July 20, 2021

Memorandum

Subject: **SITE PLAN REVIEW** — 1208 S. Croatan Highway in the Commercial Zone — Proposed 2,500 Sq. Ft. Drive-Thru Restaurant, 25 Parking Spaces, and Associated Site Modifications.

UTILITY PLAN

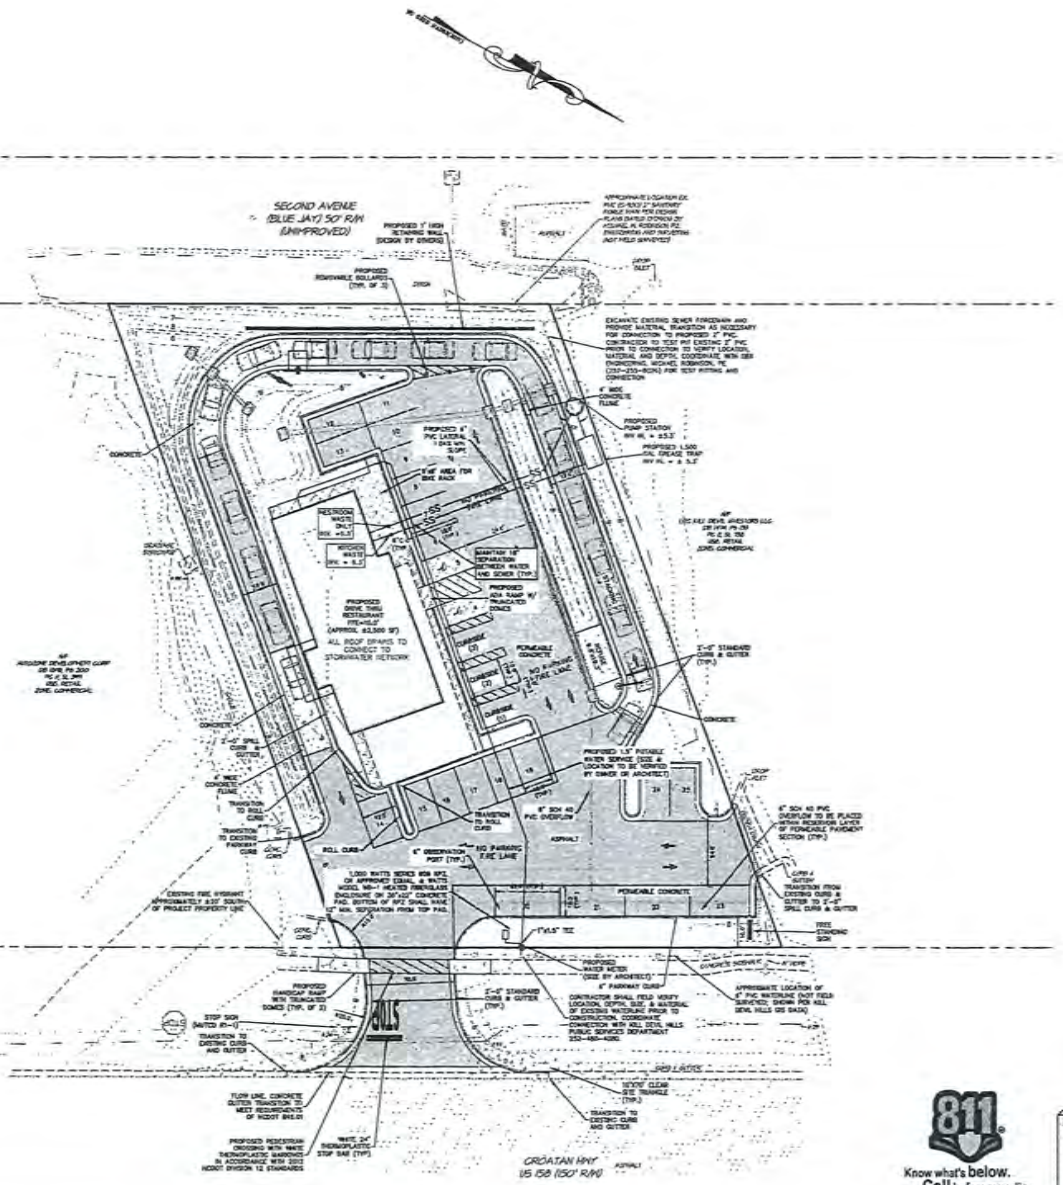
1. Dimension the radii of the entrance curb returns.
2. On Sheet 2, relabel the "site triangle" as "sight triangle."

1. Engineering
   b) Dimension the radii of the entrance curb returns. *Please see added dimensioning of the entrance curb throughout the plan set.*
   c) On Sheet 2, relabel the "site triangle" as "sight triangle." *See revised edit on Sheet 1 (previously sheet 2) "sight triangle."*

SHEET NO. 6 OF 8 SHEETS

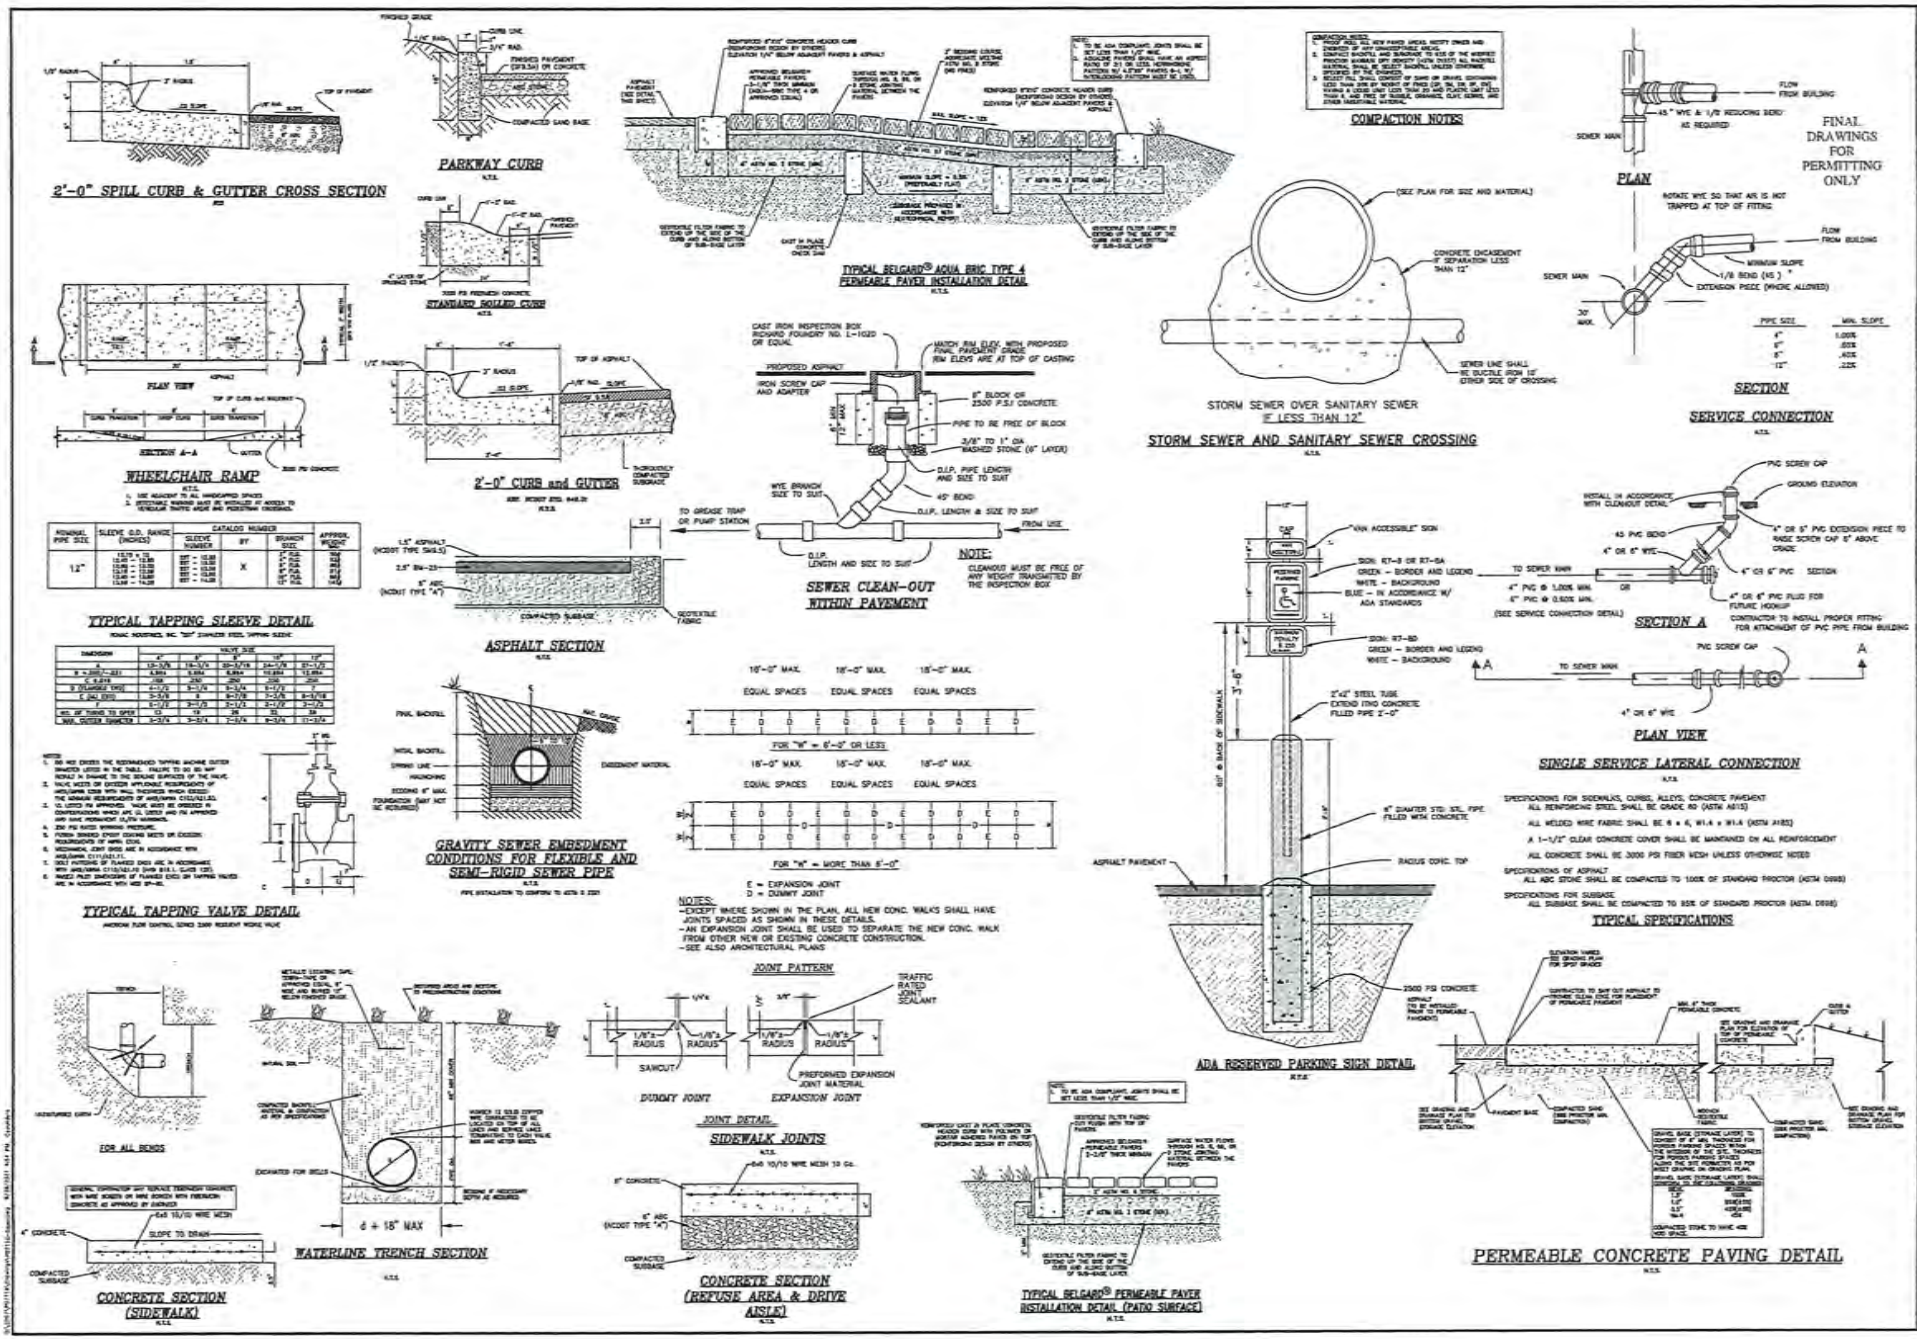
4. Sheets 3 and 4: Remove note "Proposed Removable Bollards (typ. of 3)"
5. Sheet 6: Landscaping Planting Summary does not meet the required number of plantings. Please provide breakdown of required and provided plantings (trees and shrubs) per property line. Required landscaping plantings are as follows: NCDOT Buffer - Trees: 15 Shrubs: 15, Northern Buffer - Trees: 8 Shrubs: 23, Southern Buffer - Trees: 8 Shrubs: 23, Western Buffer - Trees: 15 Shrubs: 15

1. My comments of June 21 have generally been addressed satisfactorily, except for #7 (referred to as h in the resubmittal letter). It stated "Please note that Pervious Concrete, or Permeable Concrete, shall be installed in accordance with the latest version of ACI 522.1, *"Specification for Pervious Concrete,"* shall have a minimum void ratio of 15%, and shall be by a contractor with demonstrated successful prior experience in the installation of Pervious Concrete." The engineer acknowledges this in the resubmittal letter, but when we said "Please note...", we meant that an actual note to this effect should be placed near the *PERMEABLE CONCRETE PAVING DETAIL* on Sheet 7.
2. Also, a minor detail: In the *TYPICAL BELGARD® AQUA BRIC TYPE 4 PERMEABLE PAVER INSTALLATION DETAIL*, the callout "MINIMUM SLOPE 0.5% (PREFERABLY FLAT)" should read "MAXIMUM SLOPE 0.5% (PREFERABLY FLAT)".

REFUSE EXHIBIT

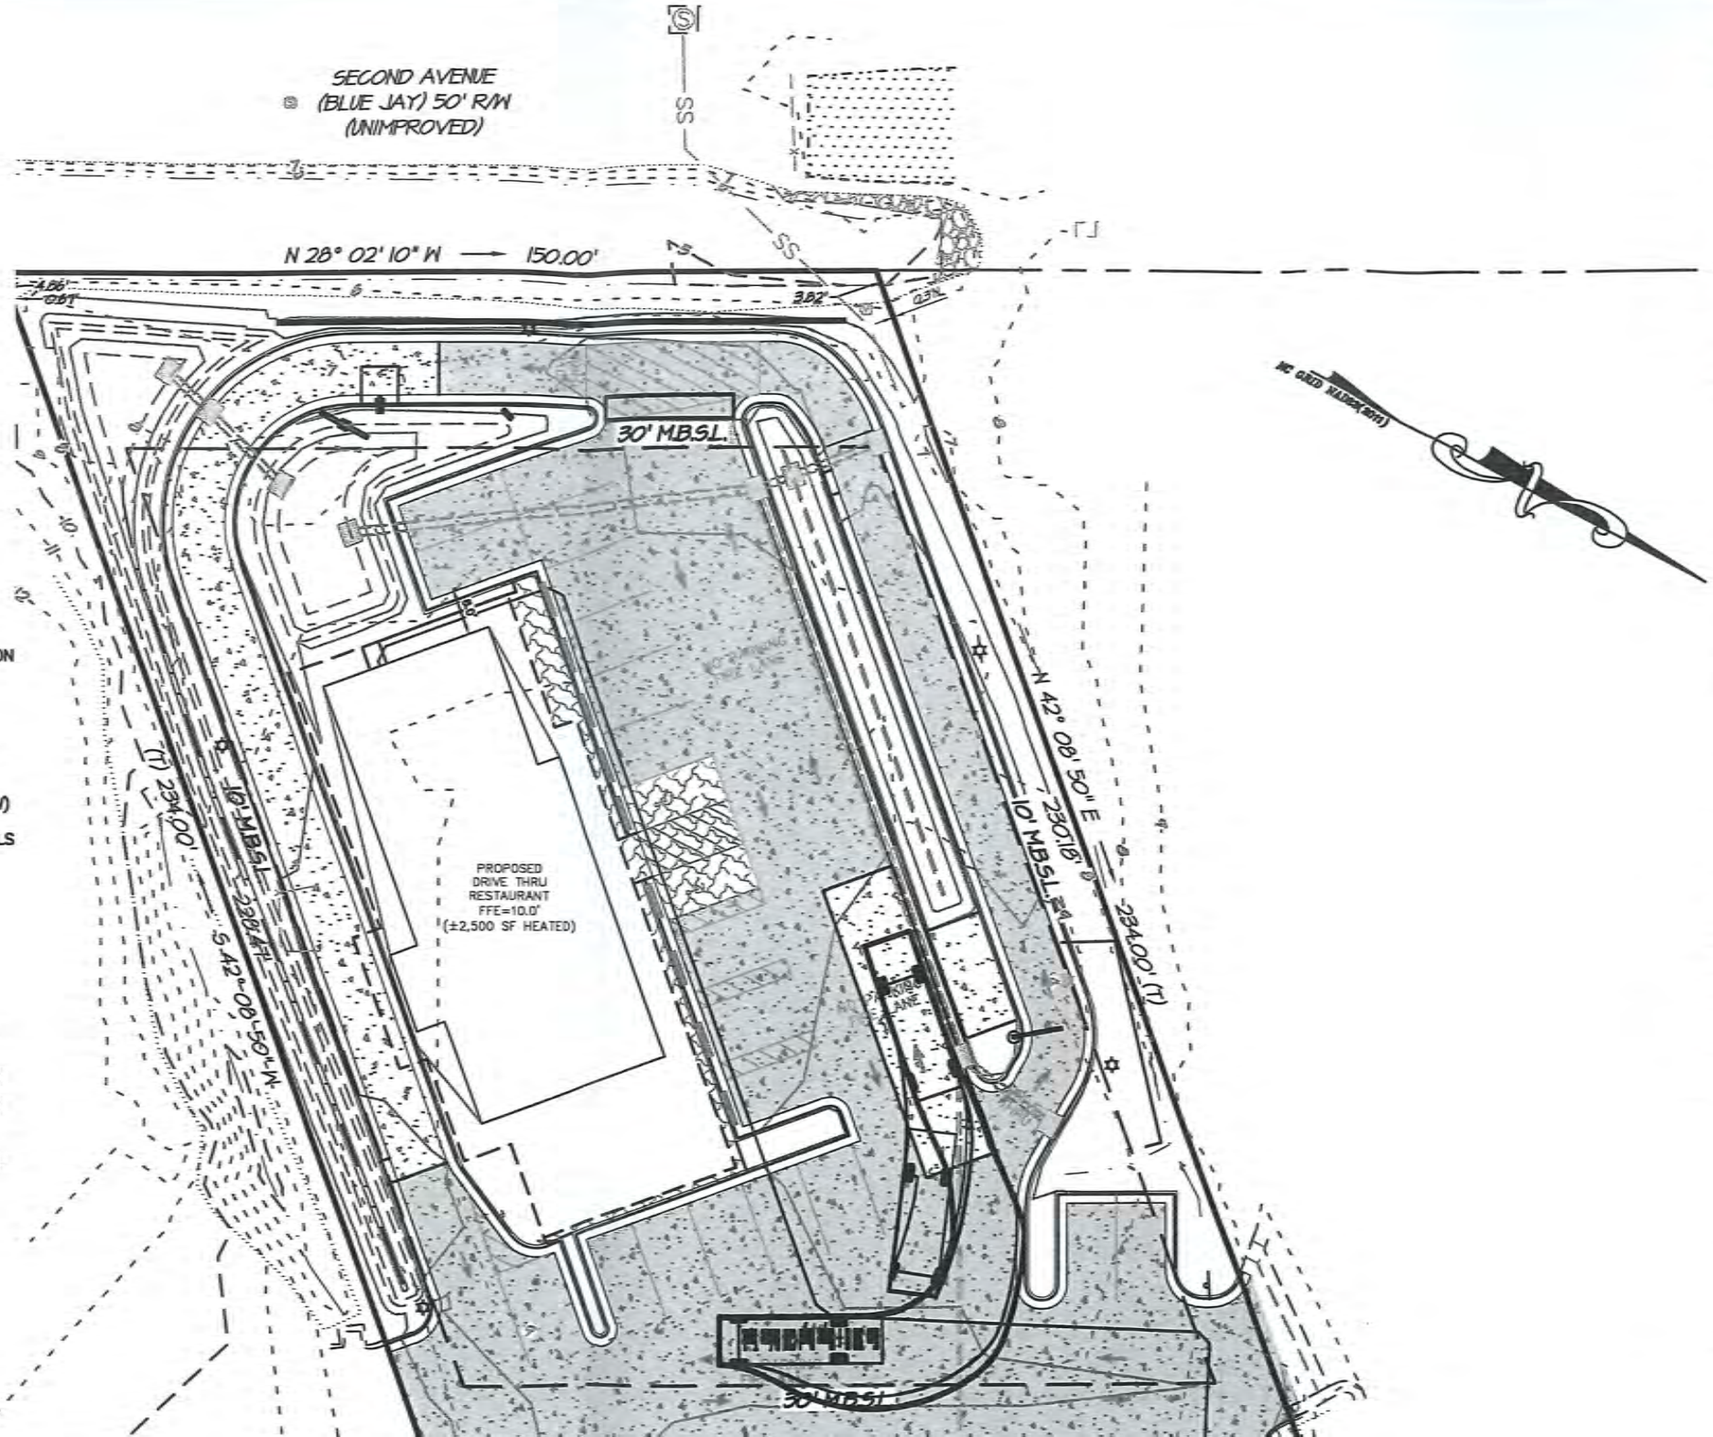
c. Provide truck turning template for refuse dumpster service vehicle backing into dumpster service area. *Please see attached truck turning template.*
